NOTICE OF A PUBLIC MEETING
Dallas Center City Council
Tentative Agenda
August 24, 2023 – 6:00 pm – Memorial Hall
1502 Walnut Street, Dallas Center

P&Z Report – August 22, 2023

SITE PLAN FOR: CASEY'S STORE #4335

DALLAS CENTER, IOWA
CASEY'S STORE 4335
SITE PLAN

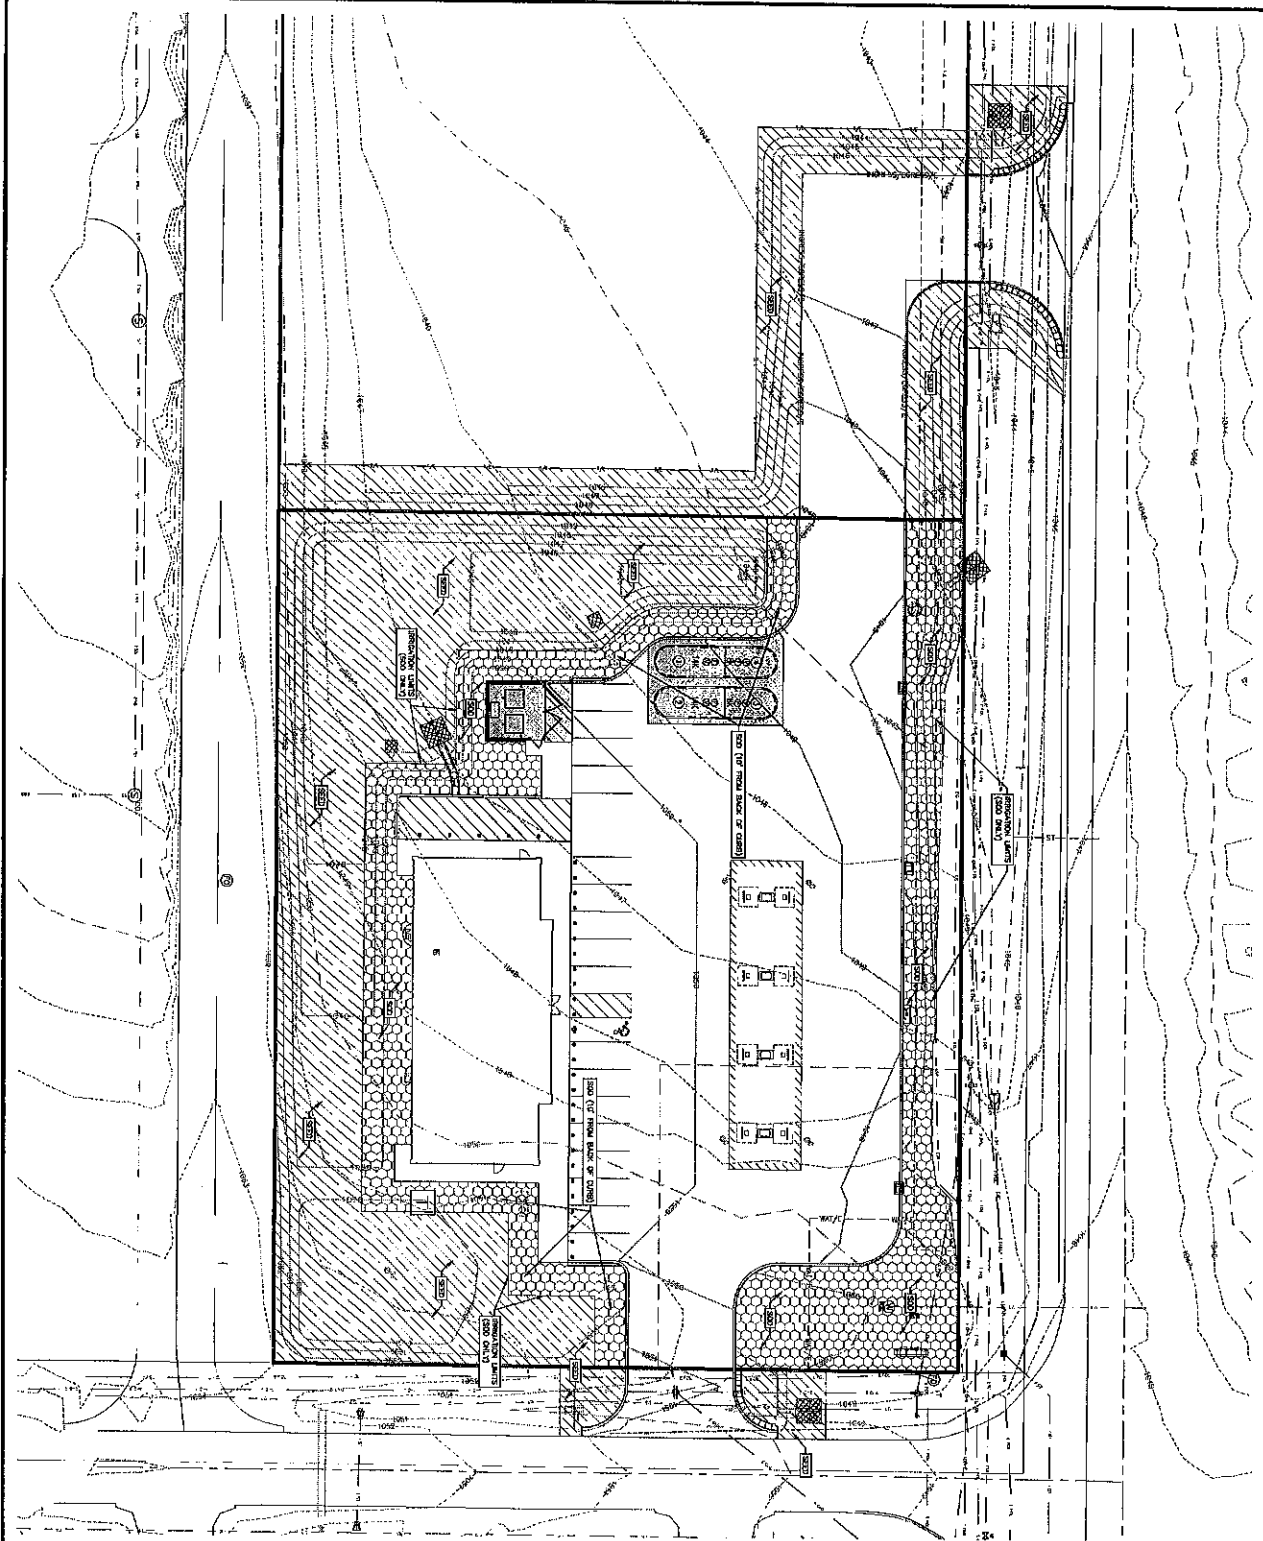
29. The landscaping plan shows the areas disturbed by construction will predominantly be seeded. There are areas around the building and on the north side of the parking lot area that will be sodded.

30. The landscaping plan does not show and trees, shrubs, or similar plant material to be provided.

3. A landscaping plan as provided in Section 158.07(2)(Q) of the Code of Ordinances of the City of Dallas Center, Iowa, shall be provided by the applicant, which plan shall be reviewed and approved by the City Engineer.

3. A landscaping plan as provided in Section 158.07(2)(Q) of the Code of Ordinances of the City of Dallas Center, Iowa, shall be provided by the applicant, which plan shall be reviewed and approved by the City Engineer.

2 Exterior Elevation - Left Side of Building (Plan East)
1/4"=1'-0"

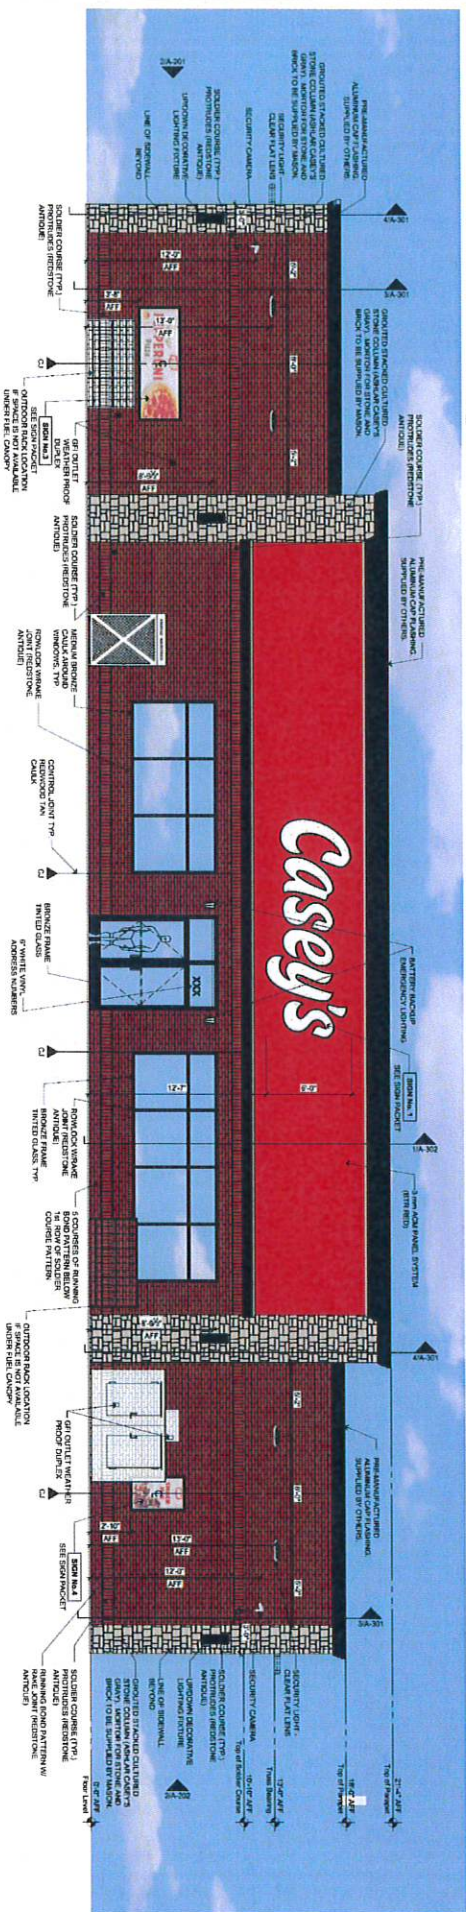
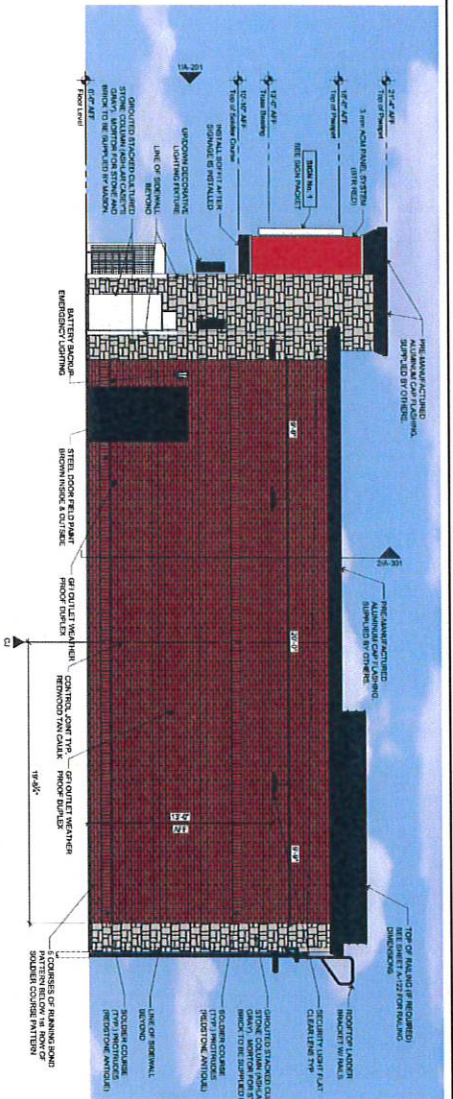
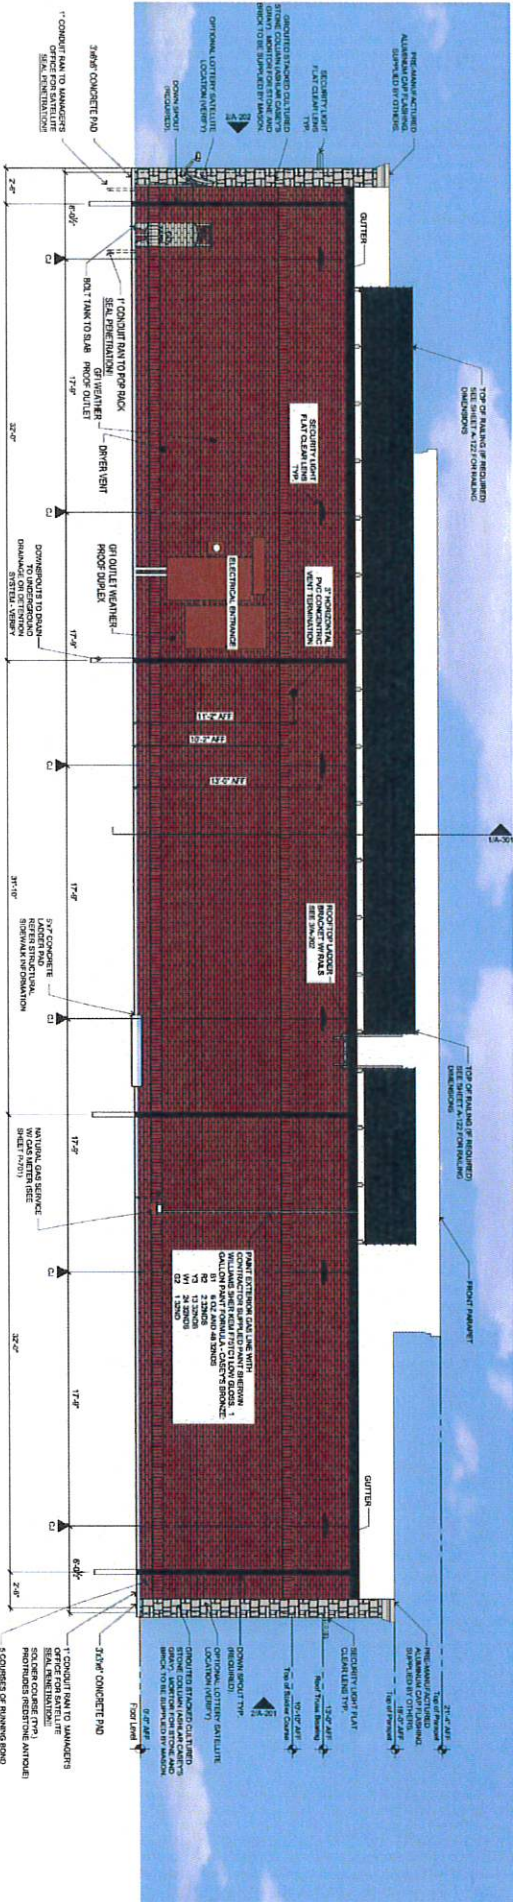
31. The architectural plan indicates the predominant material on all four sides of the building will be a brick material. A secondary material for the pillars will be a cultured stone.
32. The front of the building includes a red ACM panel system.
33. The brick and cultured stone would appear to meet the City's architectural standards.
34. The site plan should include a calculation of the percentage of the materials of construction to allow for a determination whether the design meets the requirements of the City's architectural standards.

WHEREAS, the Plan as submitted indicates the predominant material on all four sides of the building will be a brick material and a secondary material for the pillars will be a cultured stone. The plan includes a red ACM (aluminum composite material) panel system for the front of the building. The identified primary exterior materials constitute more than 75% of the faces of the building as required by Section 158.10 (1) of the Code of Ordinances of the City of Dallas Center, Iowa, as amended; and
